Oyster Creek Generating Station
Facility Operating License No. DPR-16
NRC Docket No. 50-219

Subject: Response to Request for Additional Information Concerning the Fourth Ten-Year Interval Inservice Inspection Program

RESPONSE TO REQUEST FOR ADDITIONAL INFORMATION

DIAGRAM A

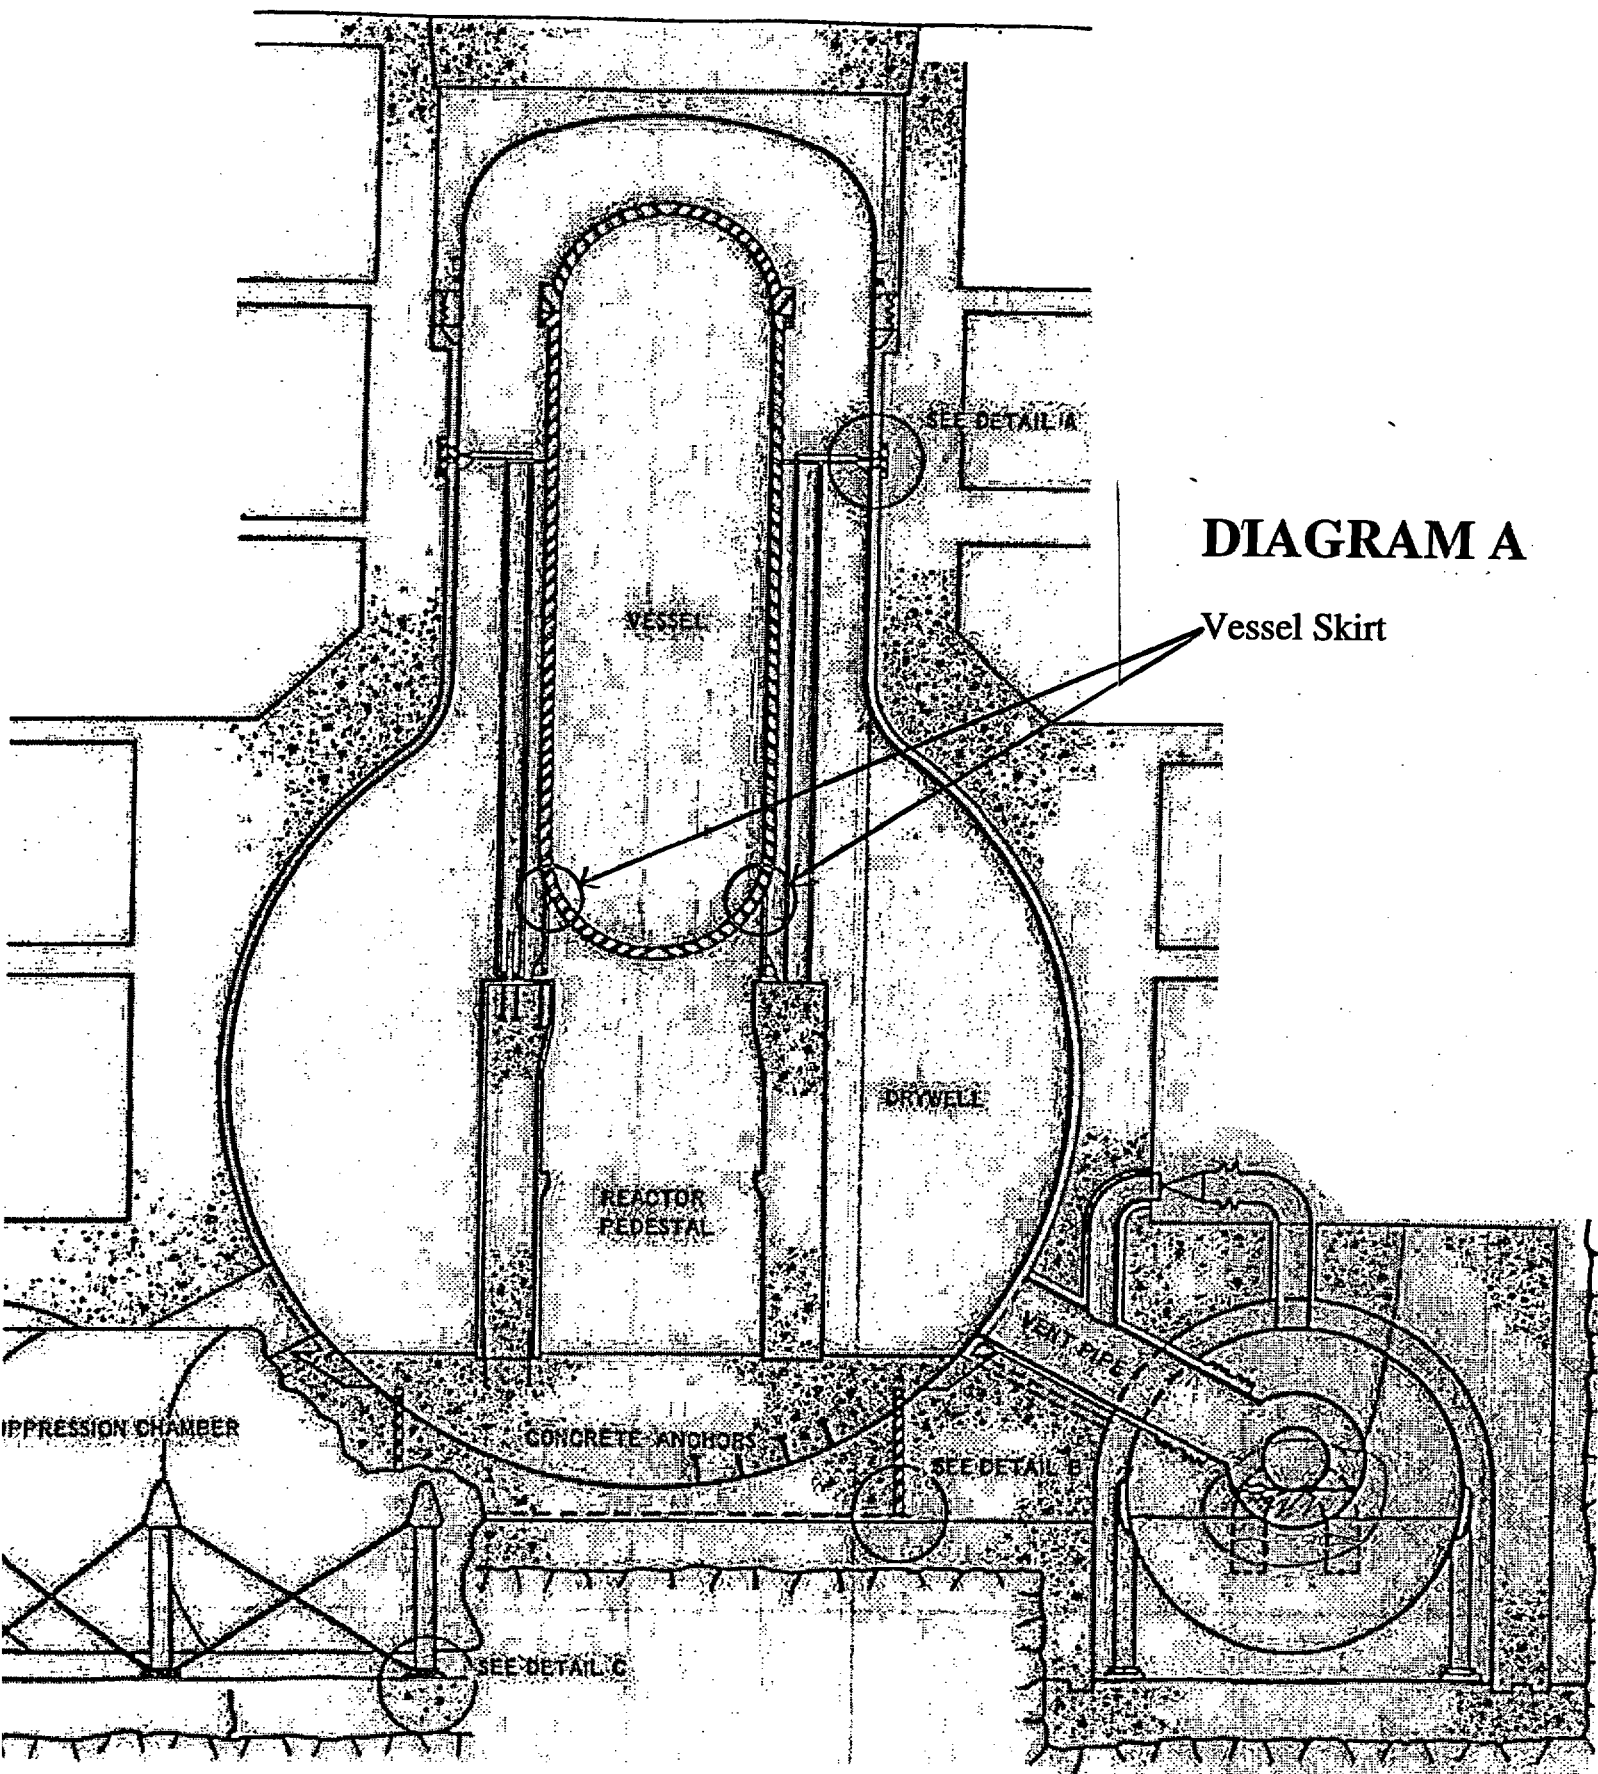
A typical configuration as shown in Figure IWB-2500-13 has been presented. However, the licensee has not provided sufficient detail to demonstrate the impracticality of the surface examinations, due to these specific interferences at Oyster Creek. Please provide, through drawings or sketches, photographs, or more detailed technical descriptions, further information to support a determination of impracticality. Include in this information the variables that produce the surface examination limitations with respect to magnetic particle or liquid penetrant testing.

The licensee argued that their nondestructive examination group pursued the use of an alternative ultrasonic method in lieu of the required surface examinations on the inside surface area C-D of Weld 1-569. The licensee concluded that, due to the unique configuration of the Oyster Creek RPV skirt design, an ultrasonic examination would not provide Code examination coverage. However, no physical description or other

component specific information has been provided to support this conclusion. The Staff notes that other licensee's with typical RPV skirt weld configurations have applied ultrasonic methods to examine all or large percentages of the Code-required surface areas. Please provide sufficient information to enable the Staff to determine whether ultrasonic techniques may be applied at Oyster Creek.

The licensee stated, as part of their alternative examination, that Oyster Creek will "perform a VT-3 visual examination of the support skirt IWB boundary as shown in Figure IWB-2500-13 for any support deformation." It is unclear whether the VT-3 visual will be conducted as a direct, or remote, inspection, and whether the IWB boundary is intended to include the surface areas A-B and C-D, as described in Figure IWB-2500-13. It is also unclear what is meant by the phrase "any support deformation." Please clarify.

The support skirt does not contain personnel access holes or inspection ports that would allow examination of the C-D surface area to the extent required by the Code. Attached Diagram A provides a view of the Oyster Creek vessel and the location of the vessel skirt. As discussed in our relief request, control rod drive housings and incore housings restrict access for examination of area C-D. Diagram B shows the location of the skirt, and as shown on Diagram B, no access points are provided for examining area C-D. Diagram C provides a closer view of the skirt and refers to Detail "E" which is shown in Diagram D. As discussed in the relief request, an ultrasonic examination was considered as an alternative, but as shown on Diagram D, the 1 1/2 inch radius demonstrates the limited capability to perform this type of exam. As discussed in the relief request, as an alternative to the code requirements, AmerGen proposed to perform a surface examination of area A-B, and perform a VT-3 visual examination of the IWB boundary as shown in Figure IWB-2500-13 of the relief request. This examination would inspect for support member degradation, which includes surface indications or defects.
